SPI 576
Page 4 of 6
Rev. "B"
April 12, 1968

SPI 585
Page 1 of 1
April 20, 1964

SPI 606
Page 1 of 1
February 6, 1965

SPI 610
Page 1 of 1
February 25, 1965

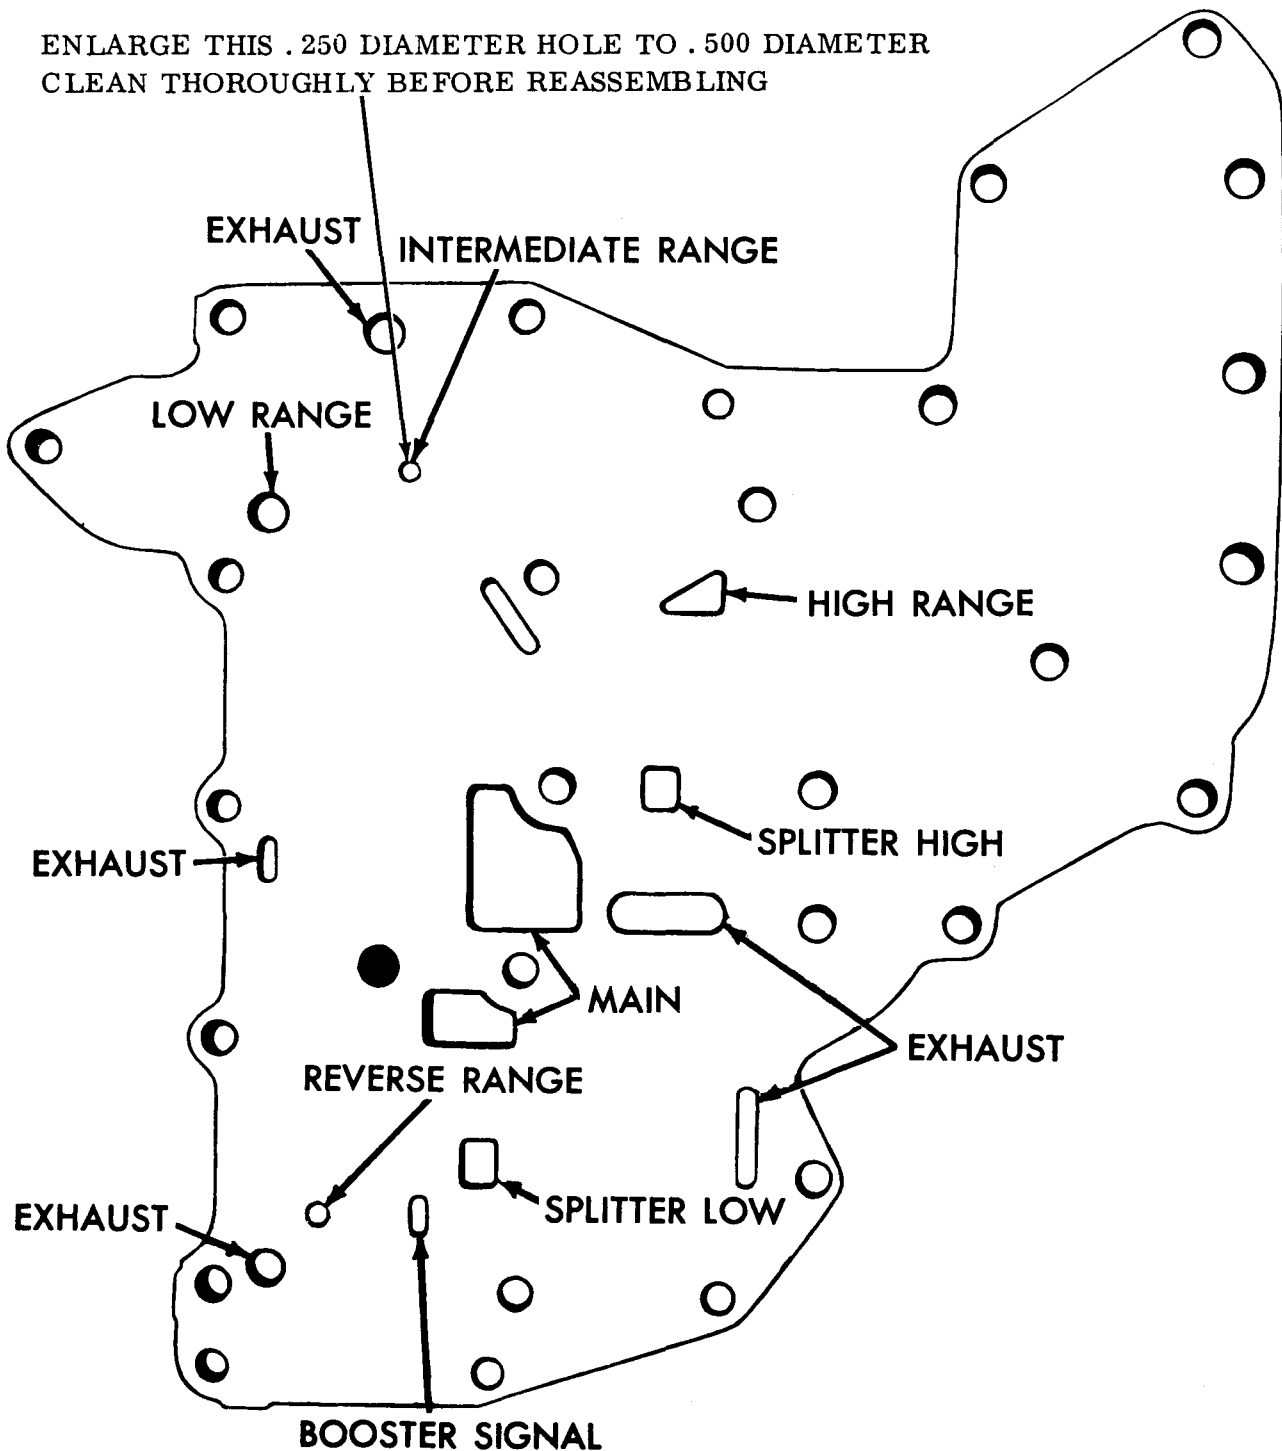
Remove the control valve body assembly and the oil transfer plate. Install the new oil transfer plate 6776681.

REWORK PLATE 6773196 TO THE 6776681 CONFIGURATION BY
DRILLING OUT THE INTERMEDIATE OIL HOLE AS SHOWN ABOVE

Figure 1. Typical Seal Installation - Seal and Expander vs. New Lip-Type Seal

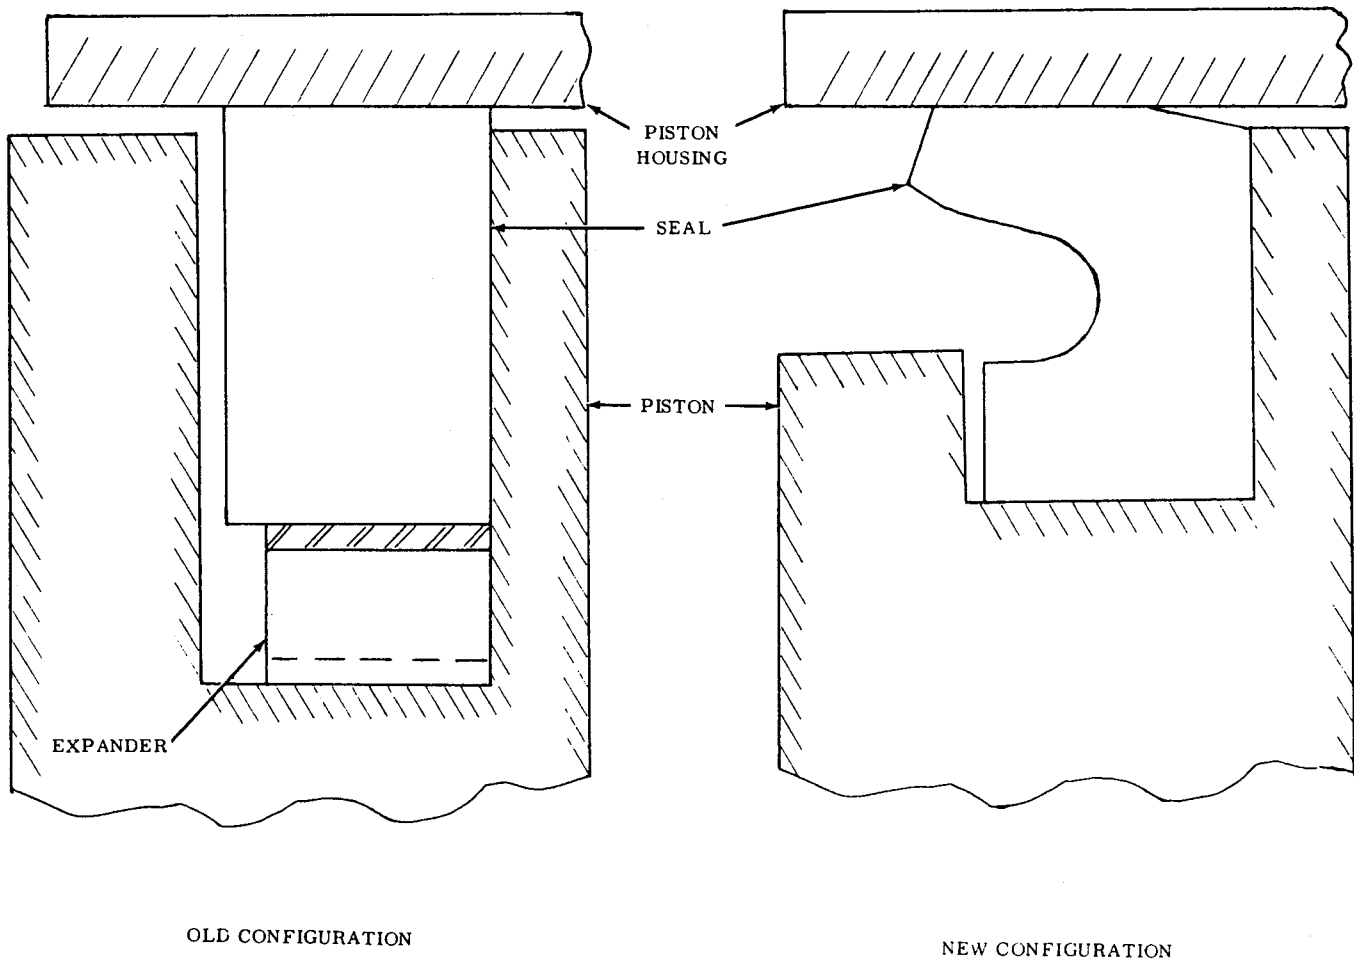
The new sealrings may be used on transmissions prior to the Effective Serial Number on Page 1, but the new mating drum, hub, housing, adapter, output cover and/or piston must also be used.

FIG. 1. LOCKUP PISTON - HOLE LOCATION AND REBORE INSTRUCTIONS

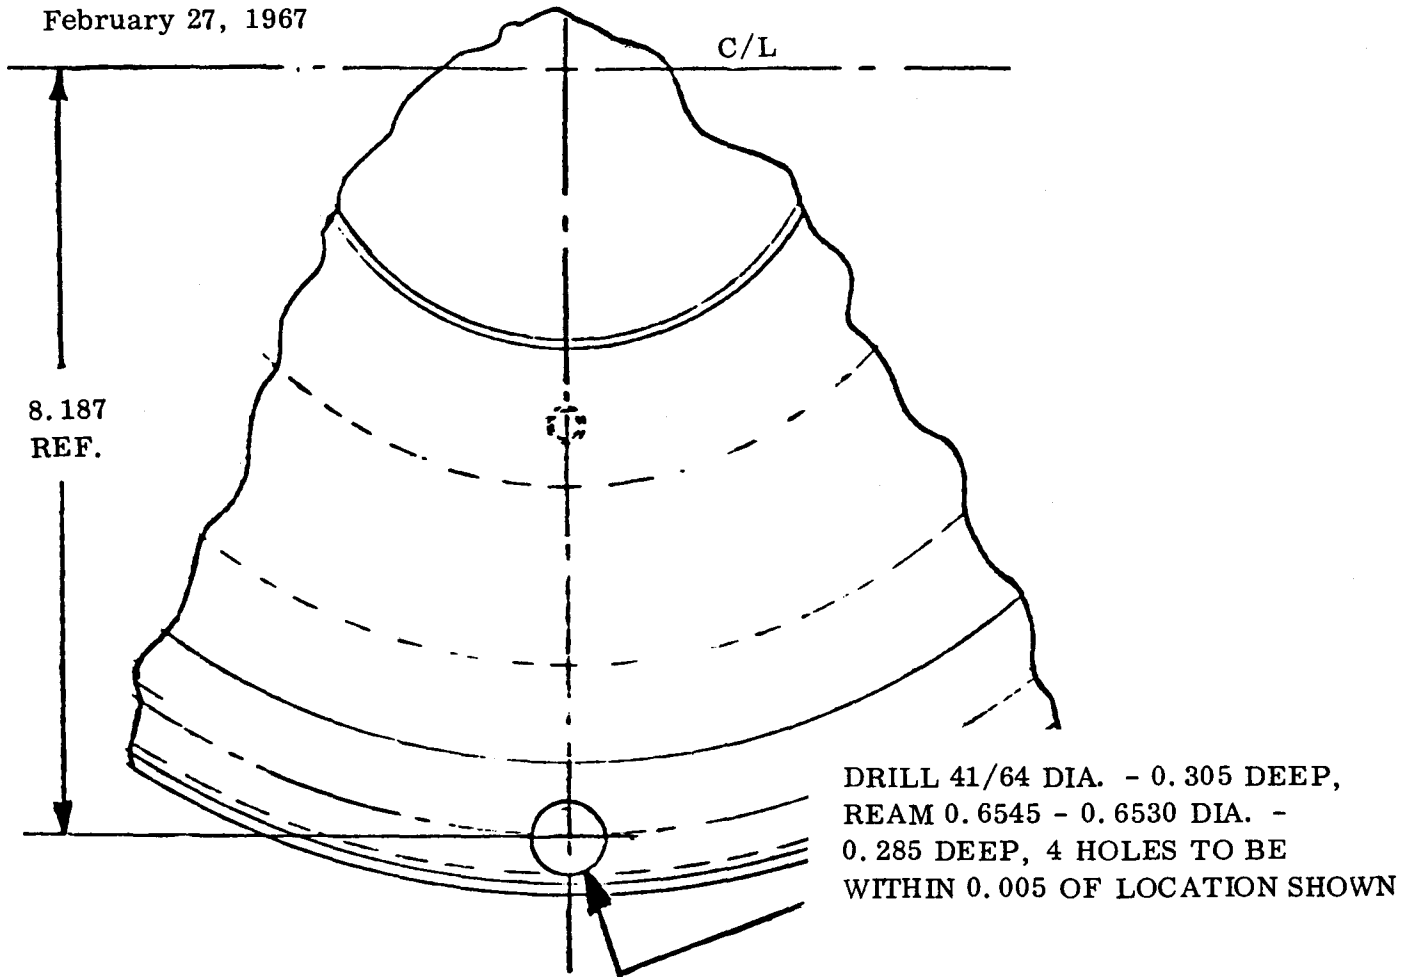
Worn guide pin bores of the lockup clutch pistons can now be reworked in the field. The rework consists of reboring and installing a bushing. If a piston is reworked, it is recommended that all four (4) bore locations should have bushing installed.

1. Drill and ream for size the four bores as indicated in Figure 1.
2. Pack the bushing P/N 6832547, in dry ice and allow to cool for a minimum of thirty minutes.
3. Install bushing, pressing it into bore, flush to 0.010 inch below bore surface. Refer to Figure 2.

FIG. 1. RETARDER VALVE BODY ASSEMBLY

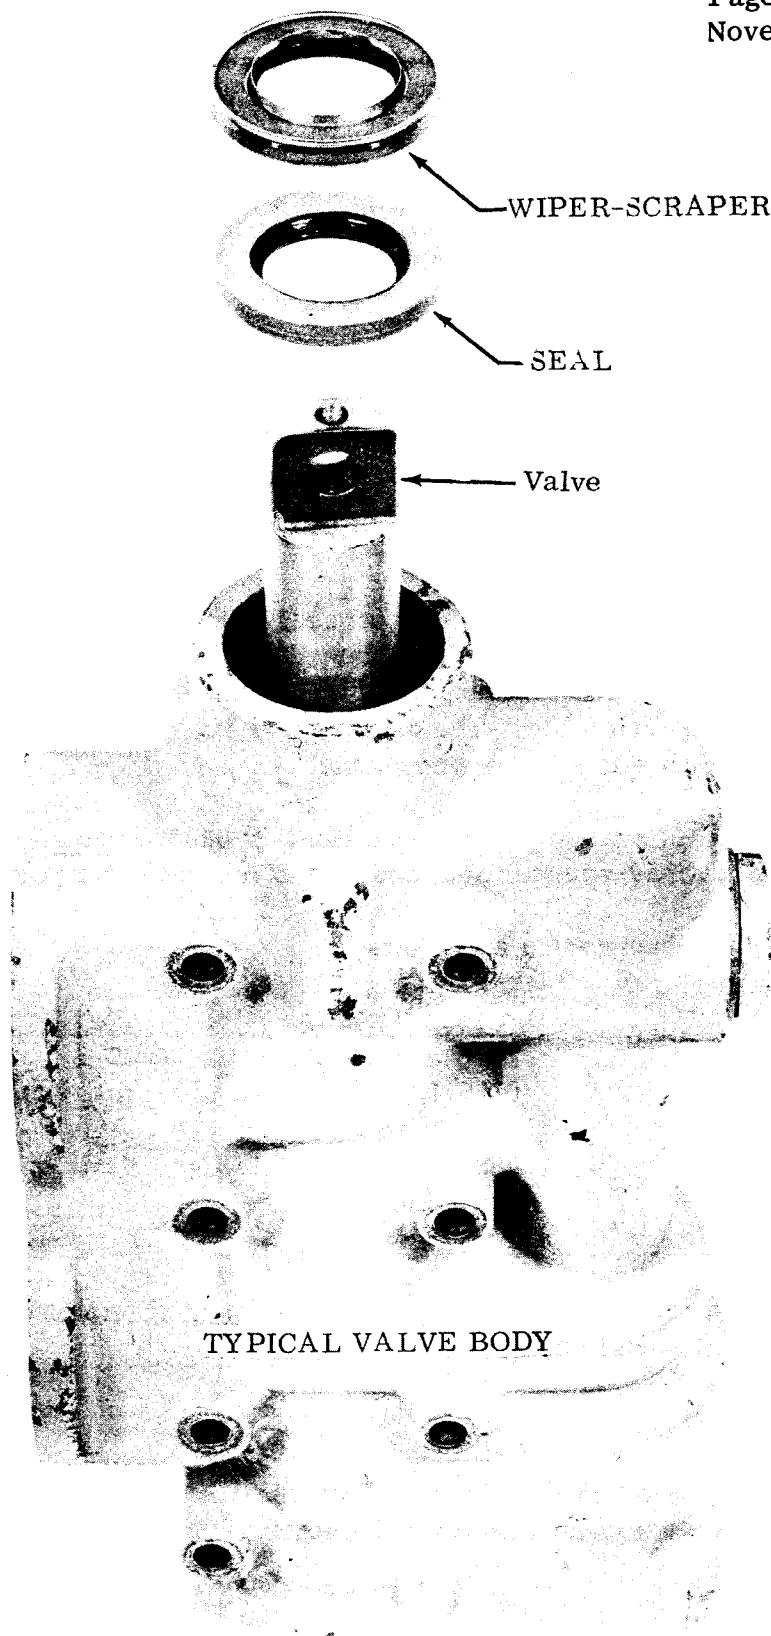
As a product improvement, a new oil seal P/N 6832559 has been released for use with the wiper-scraper seal at the retarder valve. Refer to Figure 1. The new seal reflects both construction and dimensional design changes to assure reliability and extended service life. The old seal was subject to oil leakage and a relatively short service life in some applications.

FIGURE 1. LOCATION OF SEALRINGS ON TYPICAL CONVERTER GROUND SLEEVE

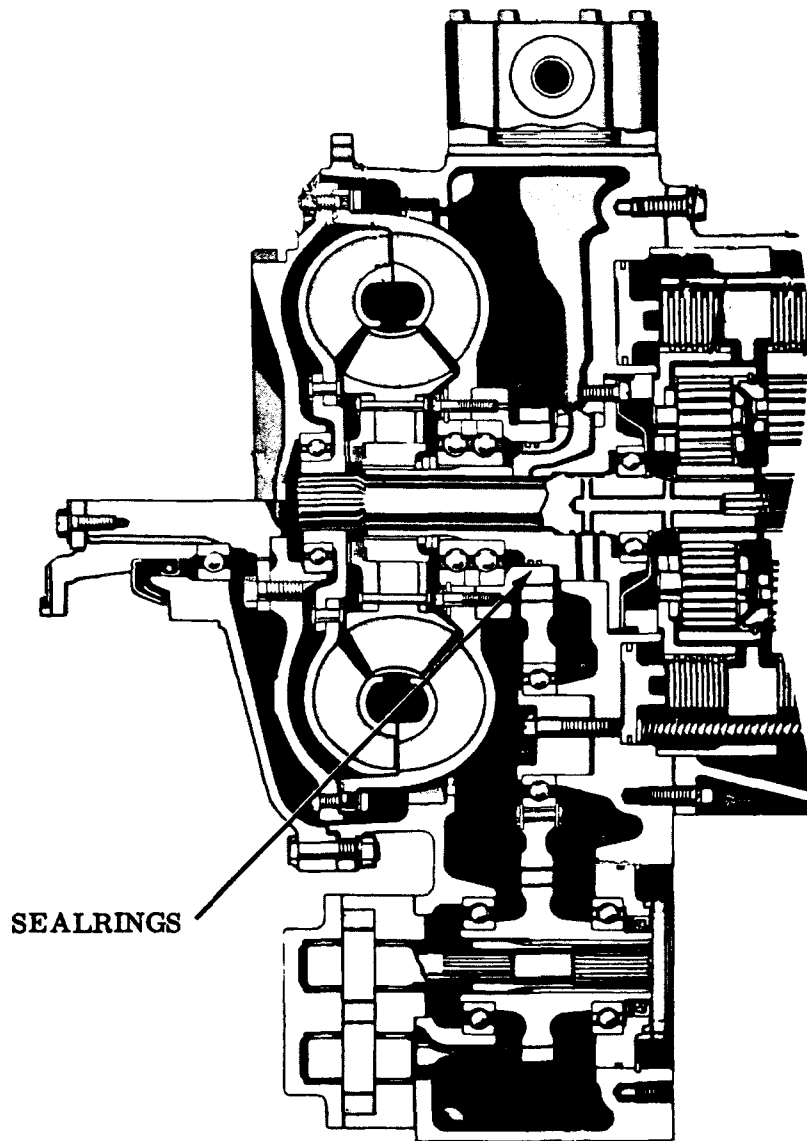
This is to advise of a quantity change of the hook-type sealrings required on the converter ground sleeve of the subject transmissions. Refer to Figure 1. As illustrated, two (2) have been used to date at this location. It has been determined that only one (1) is required. Therefore, all future production transmissions will have one sealring only at this location.

Interchangeability not affected by these changes. Ground sleeves, having one groove or two grooves, may be used in any transmission. One sealring only is required on any transmission - sealring may be installed in either groove.

FIG. 1. LOCATION OF OUTPUT PUMP CHECK VALVE IN CONV. HOUSING

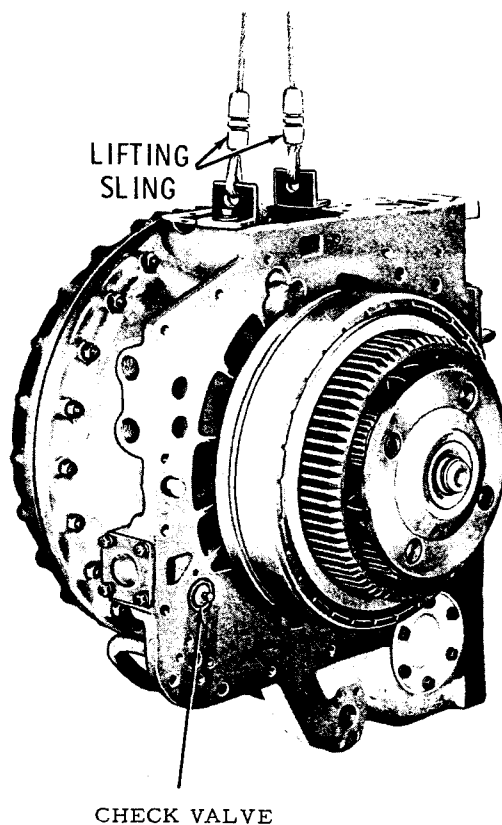
An orificed plug has been released to replace the output oil pump check valve, spring and guide located in the converter housing of the subject transmissions (Figure 1). The check valve components are required in transmissions incorporating an output (push start) oil pump assembly, however, this pump assembly was eliminated from Production build transmissions at serial number (S/N) 47641. The new plug (Figure 2) reduces the number of parts necessary at this location and provides a metered (orificed) lube oil flow back thru the oil passage for speedo gear requirement in straight-thru model transmissions. Previously, speedo lube was supplied by output pump oil and later when it was removed, by input pump oil bleeding back thru the check valve to the gears.

FIG. 2. ORIFICE PLUG INSTALLED IN CONV. HOUSING. (REPLACES THE CHECK VALVE COMPONENTS AT THIS PORT ON NON-OUTPUT OIL PUMP TRANSMISSION ASSEMBLIES.)

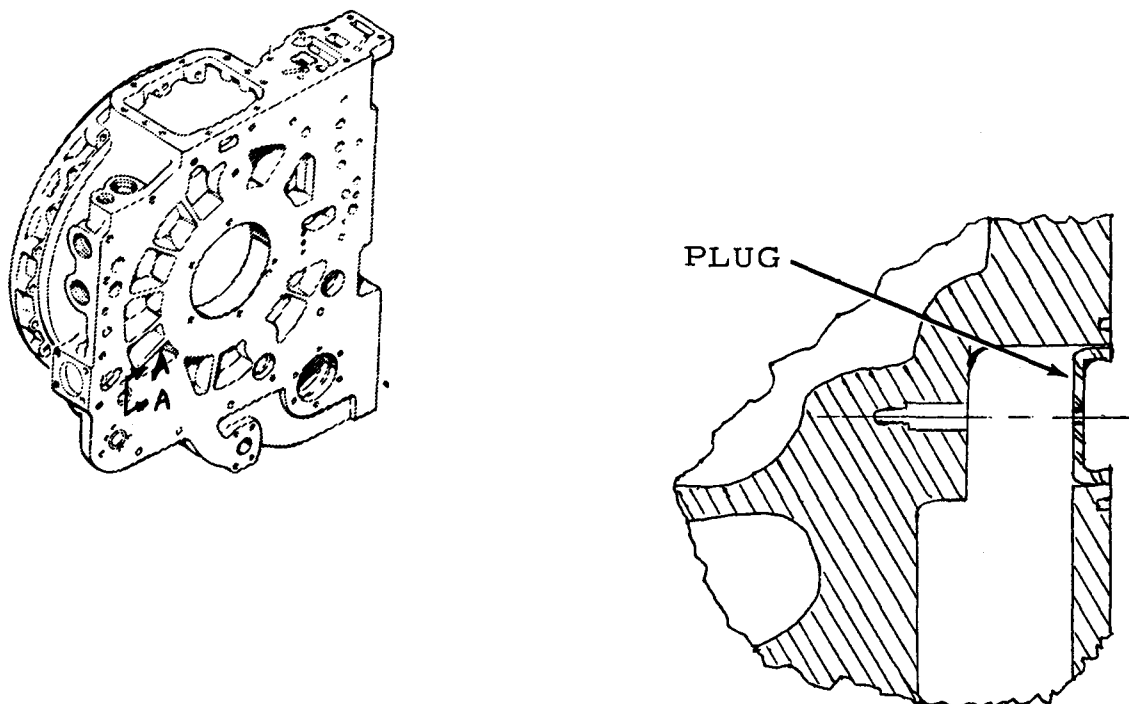
1. Remove output pump check valve, spring and guide. Remove by twisting and pulling out on guide.
2. Install plug, cup side out, into converter housing flush with the housing splitline as illustrated in Figure 2.

FIGURE 3. TRANSMISSION HOUSING-REWORK AREA

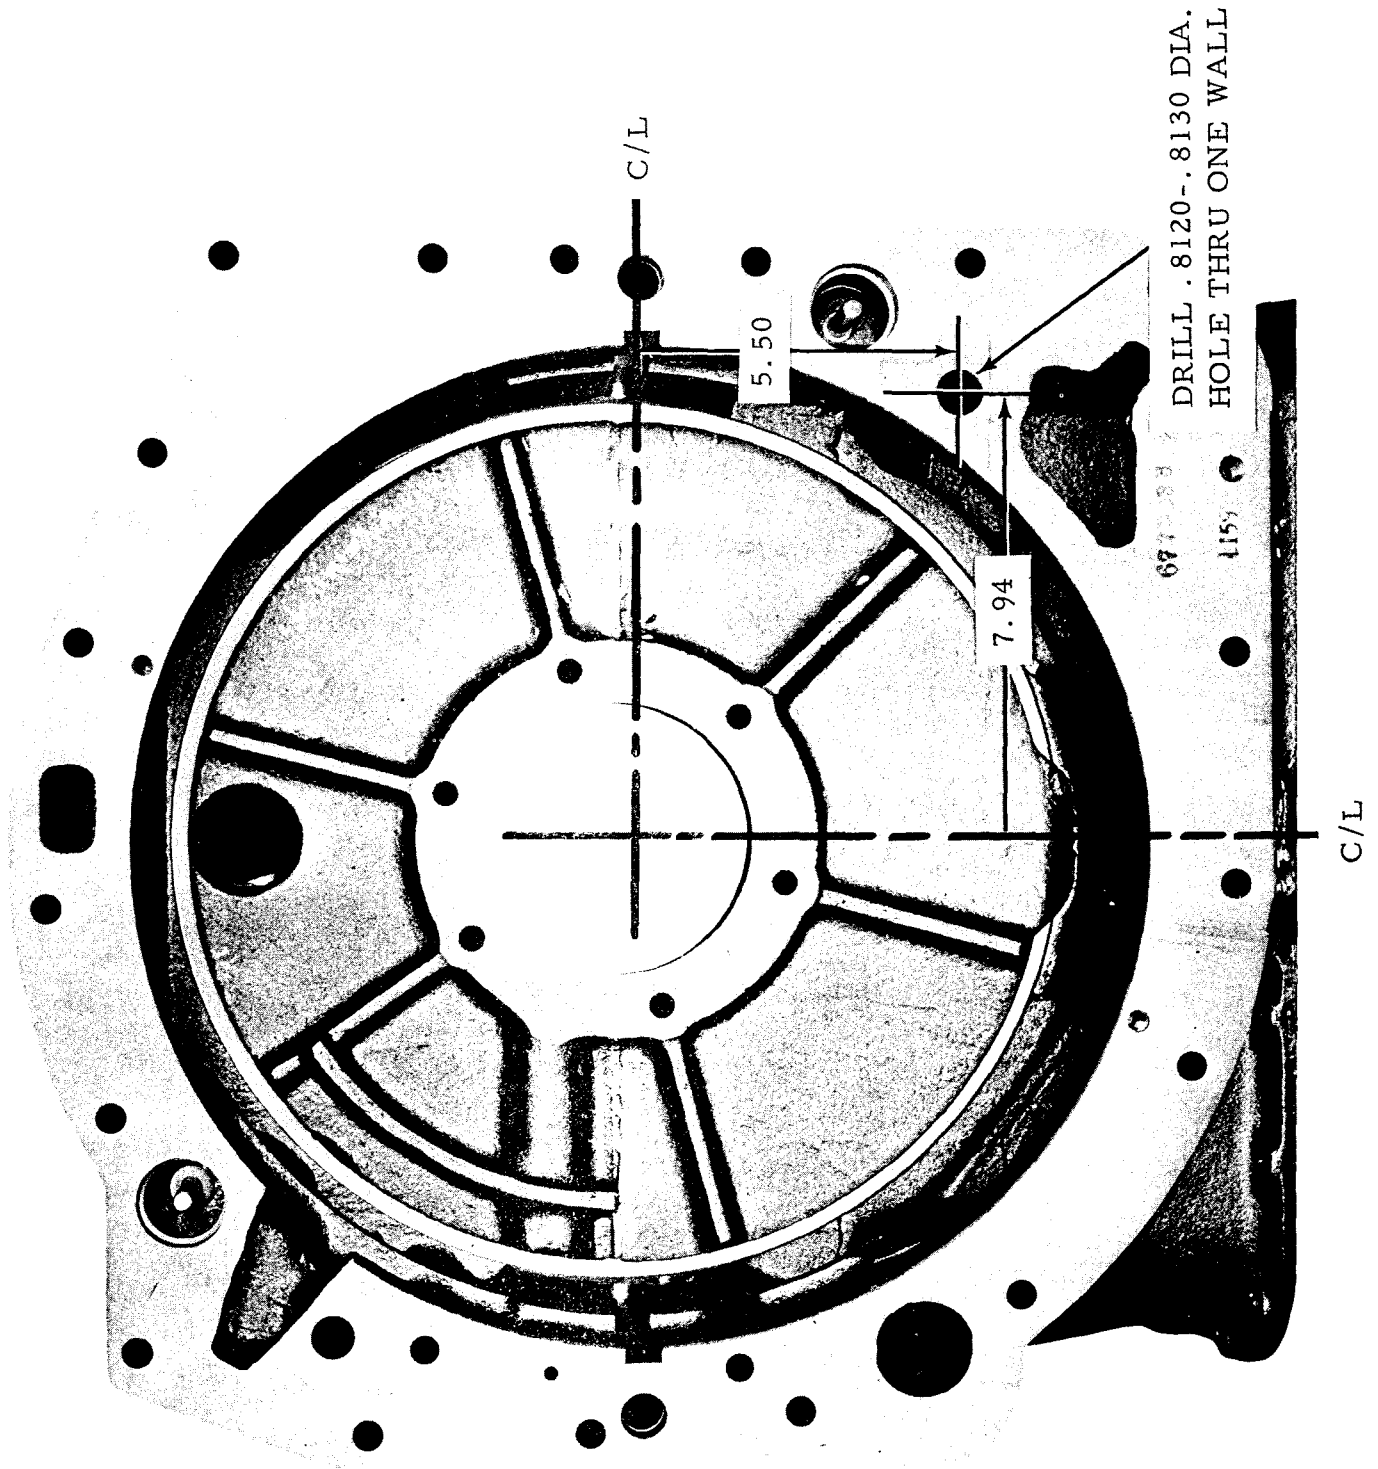
Transmission main housing assembly P/N 6773236 is used in some drop box model transmissions. This particular housing blocks the lube oil coming thru the check valve, resulting in oil leakage at the main housing-to-retarder housing (or converter housing on non-retarder models) splitline. This lube supply is not required on drop box model transmissions. To eliminate the leakage problem which can occur even with the new orifice plug, an exhaust hole is being added at the front splitline of the housing.

1. Locate and drill 0.8120-0.8130 inch diameter hole thru one wall. Refer to Figure 3.
2. Be sure to remove all drill debris from housing after rework.
